REQUEST FOR TECHNICAL CHANGE

AGENCY: Building Code Council

RULE CITATION: NC Building Code, Chapter 2

FIGURE R4603.6(e)
CORNER PILE CONNECTION

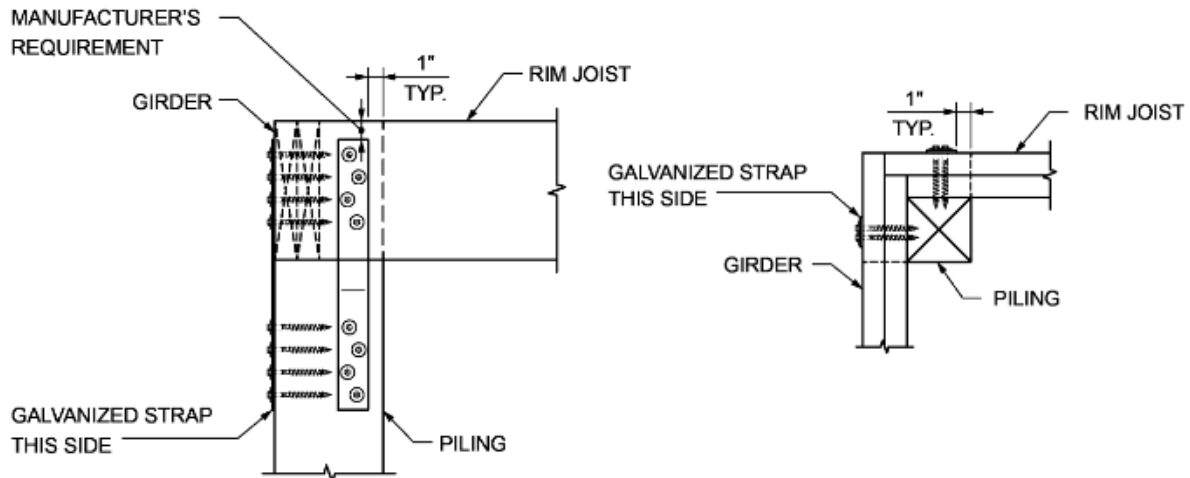
Why is Figure R4603(e) included with this Rule? It appears it should be attached to the filing for the Residential Code, R4603. Please delete it here.

FIGURE R4603.6(e)
CORNER PILE CONNECTION

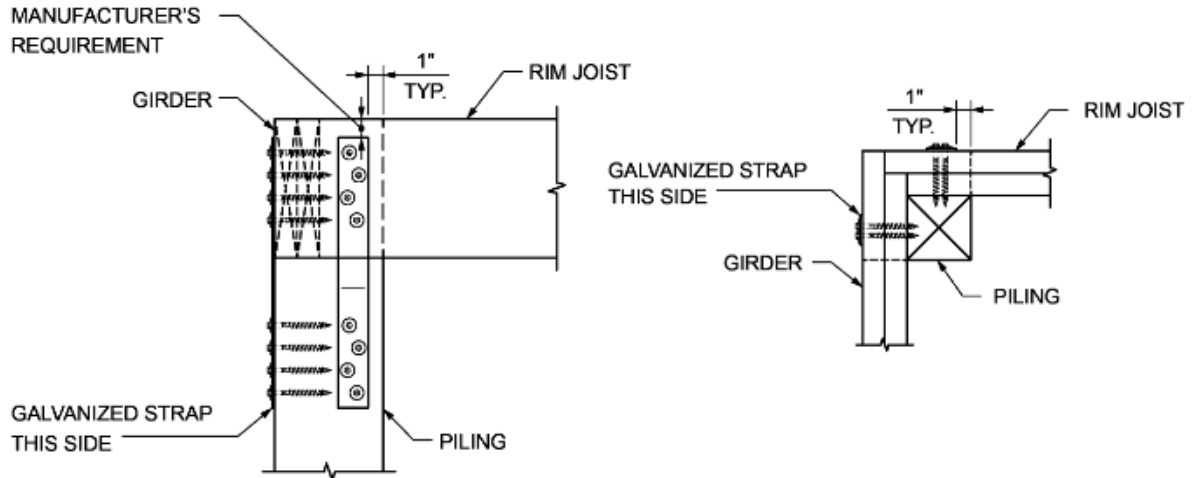
Why is Figure R4603(e) included with this Rule? It appears it should be attached to the filing for the Residential Code, R4603. Please delete it here.

FIGURE R4603.6(e)
CORNER PILE CONNECTION

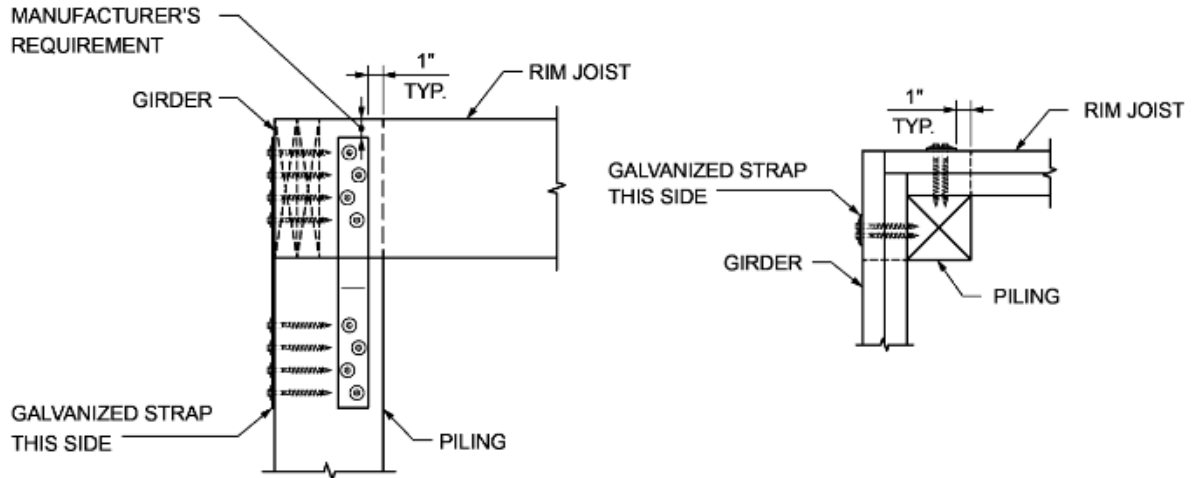
Why is Figure R4603(e) included with this Rule? It appears it should be attached to the filing for the Residential Code, R4603. Please delete it here.
